**ALERT SERVICE BULLETIN**  
REVISION NOTICE  
**Bell Helicopter****TEXTRON**  
A Subsidiary of Textron Inc.

SUBJECT: **REVISION "A" TO ALERT SERVICE BULLETIN 206L-09-158:  
AIRWORTHINESS INSPECTION LIMITATION TO TAILBOOM LEFT  
UPPER ATTACHMENT FITTING P/N 206-032-409-001.**

NO. 206L-09-158

REV A

**FIGURE 1: INTRODUCTION OF AIRWORTHINESS INSPECTION LIMITATION TO TAILBOOM ATTACHMENT FITTING P/N 206-032-409-001**

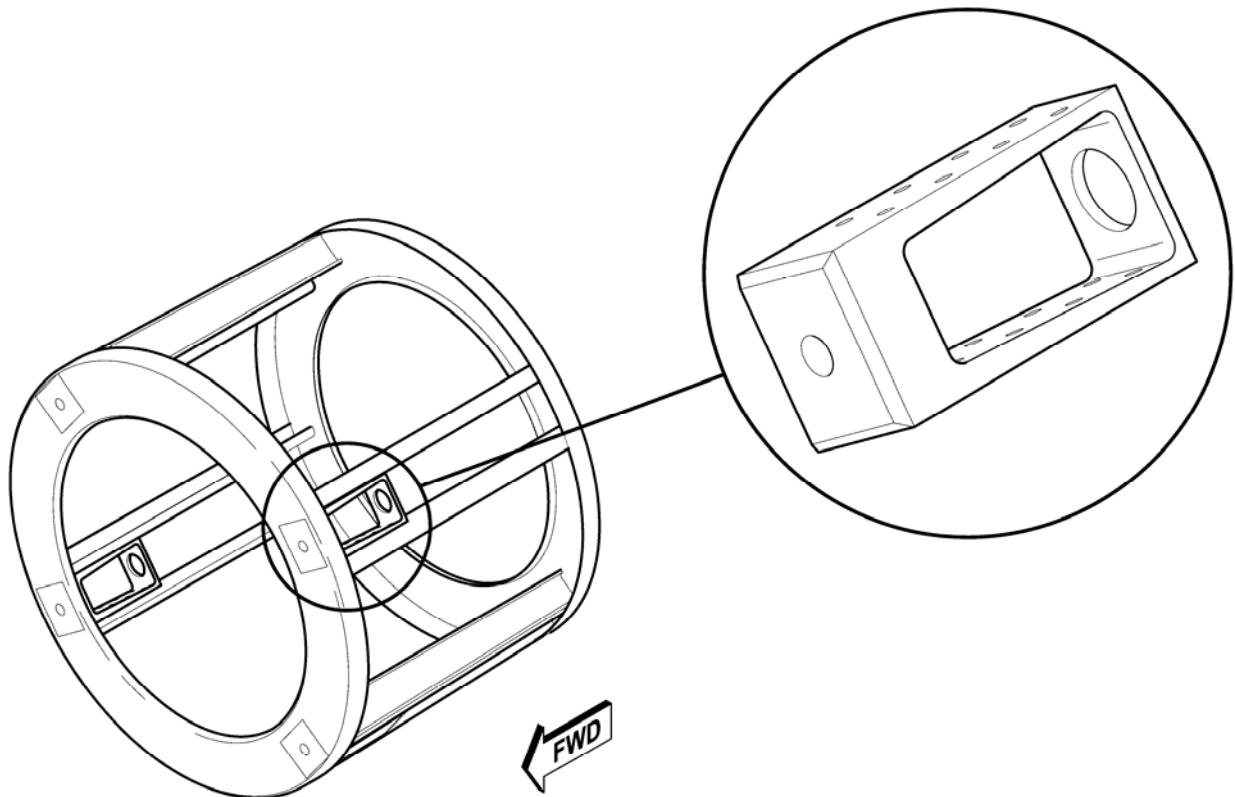
1. Inspect upper left attachment fitting P/N 206-032-409-001 for a crack, corrosion, loose rivets, mechanical damage and general condition within a period not to exceed 100 hours of flight time.
2. Repair fitting in accordance with **PART I** and Figure 2 provided limitations are met after rework.
3. Replace cracked or damaged fitting or loose rivets in accordance with **Part II** of this bulletin.
4. Tailboom assembly remaining details not shown for clarity.
5. If a crack is found, contact Product Support Engineering with details using the following information;

2. (Ref. Figure 1) Inspect and mark head of any visible loose rivet found on attachment fittings with indelible ink felt pen before cleaning the complete tailboom attachment area with aircraft soap (C-318). Prepare soap solution per manufacturer's recommendations to remove all traces of dirt, stains, exhaust residues and oil. Rinse area with water and let area to dry.

**FIGURE 2: DAMAGE LIMITATION AND APPROVED REPAIR TO FITTING P/N 206-032-409-001 (Sheet 1 of 2).**

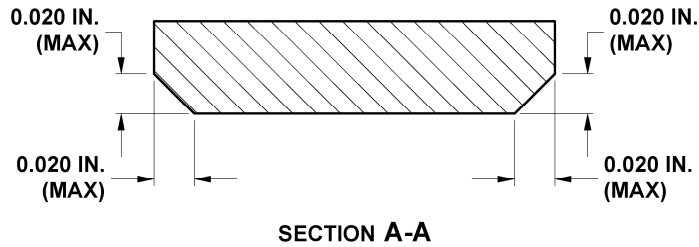
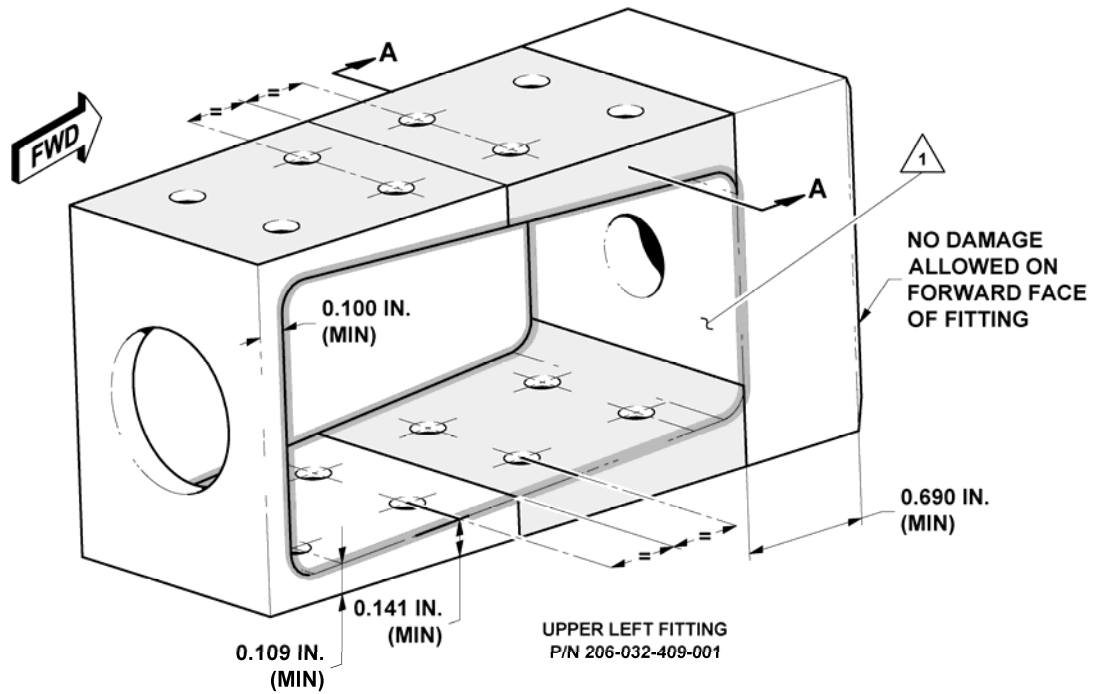
- 
 NO DAMAGE ALLOWED. IF DAMAGE FOUND, CONTACT PSE.
-  MAXIMUM 0.020 INCH x 45° CHAMFER (SEE SECTION A-A).M
-  0.015 INCH MAXIMUM.

- A**
1. If damage removal is required on inner end pad surface, ensure that the blend area is wide enough to guarantee that the tailboom bolt head is sitting on a flat surface. After machining or sanding, both end pad surfaces to be parallel and lie in a plane within 0.002 inch. Do not machine fitting radius. If these conditions are not met, resubmit to PSE for evaluation.

2. Typical for opposite surfaces.
  3. Clean the fitting to remove all dirt or debris before inspection.
  4. Machine or sand the fitting smooth in order to remove any damage. Care shall be taken to prevent increasing the depth of the damage. A 20:1 width to depth ratio shall be maintained. Electrical discharge machining and Electro-chemical machining are not permitted. It is permissible to remove material using sand paper. Lightly abrade fitting surfaces with abrasive paper. If machining, lubricant and slow machining shall be used to prevent excessive heat that could affect existing heat treatment. Maintain surface roughness of 32 RMS or better.

5. Perform the minimum chamfer required to remove the damage and to ensure subsequent machining provision in case of future damage. Maximum 0.020" x 45° chamfer allowed.

3. (Ref. Figure 2) Use a bright light source with a mirror and inspect visually the left upper tailboom attachment fitting P/N 206-032-409-001 for loose (working) rivets, corrosion, condition and mechanical damage. Pay close attention on each leg of the fitting for a crack near the two most forward vertical rows of rivets.
4. If a crack, loose (working) rivets, is found on upper left attachment fitting, accomplish **PART II** of this bulletin.
5. If corrosion or mechanical damage is found on the fitting, refer to FIGURE 2 to determine if the fitting can be repaired.
  - a) If damage is beyond repairable condition, replace the fitting in accordance with **PART II**.
  - b) Repair acceptable damage as follows;

Depth of repair shall be twice the depth of corrosion not to exceed the repair limits of Figure 2.

- i. Machine or sand the damage on the fitting in order to remove minimum material. A 20:1 width to depth ratio should be maintained. Electrical discharge and electro-chemical machining are not approved. If machining is chosen, lubricant and slow machining shall be used to prevent generating excessive heat that could affect existing heat treatment.
- ii. If damage is affecting the corner radius area of the fitting (see double-hatched area), blend to obtain minimum chamfer that will remove the damage. A maximum of 0.020 inch (0.508 mm) X 45° chamfer is allowed.

- iii. If damage removal is needed on inner end pad surface, ensure that the blend area is wide enough to guarantee that the tailboom attachment bolt head will sit on flat surface. Do not machine into the fitting radius. After machining or sanding, both end pad surfaces must be parallel and lie in plane within 0.002" inch (0.050 mm).
- iv. Use Sanding paper (C-423) 400 grit or finer to obtain a final surface finish of 32 RMS or better.
- v. Perform Fluorescent Penetrant Inspection of the fitting after blending is accomplished to ensure all damage is removed. Clean fitting to remove fluorescent Penetrant after inspection is done.

**FIGURE 3: REPLACEMENT OF LOOSE (WORKING) RIVETS IN TAILBOOM ATTACHMENT FITTING P/N 206-032-409-001**

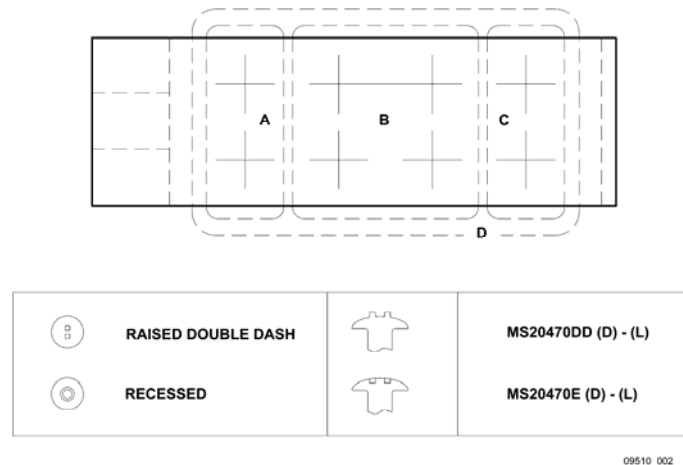
When different type or size of rivets from factory original are required due to hole(s) beyond the limit of Table 3-4 of the SRM where oversize rivet(s) is/are needed, any number of different type or oversize rivets can be installed provided the following restrictions are met:

- a) Either MS20470DD or MS20470E rivet type may be used as replacement. Only these two can be used.
- b) A minimum of 2D edge distance shall be maintained on all rivets replaced.

- c) 4D minimum pitch shall be maintained between all rivets.
- d) No rivet bigger than 3/16 diameter are allowed in any leg of the fitting.
- e) No rivets shall interfere with the installation of the hardware securing the tailboom assembly to the fuselage.

- f) No rivets should be located in the radii of the fitting.
- g) Whenever one original 5/32 fasteners needs oversize replacement, all the rivets in that affected rivet group (Group “A”, “B” or “C”) are to be replaced with the same type and size of oversize fastener.

- h) It is acceptable to have a mix of “DD” and “E” type rivets in the same leg of the fitting as shown as group “D” but it is not acceptable to have such a mix within rivet respective groups “A”, “B” or “C”.

- f) (Ref. Figure 3) Whenever one original 5/32 fasteners needs oversize replacement, all the rivets in that affected rivet group (Group "A", "B" or "C") are to be replaced with the same type and size of oversize fastener.

- g) It is acceptable to have a mix of "DD" and "E" type rivets in the same leg of the fitting as shown as group "D" but it is not acceptable to have such a mix within rivet respective groups "A", "B" or "C".

**Example 1:** (Ref, Figure 3) A rivet hole in part of group "A" is elongated (oversize); both rivets in group "A" must be replaced.

**Example 2:** (Ref. Figure 3) Two rivet holes, one in group "A" and the other in group "B" are elongated (oversize); all rivets in both groups ("A" and "B") must be replaced.
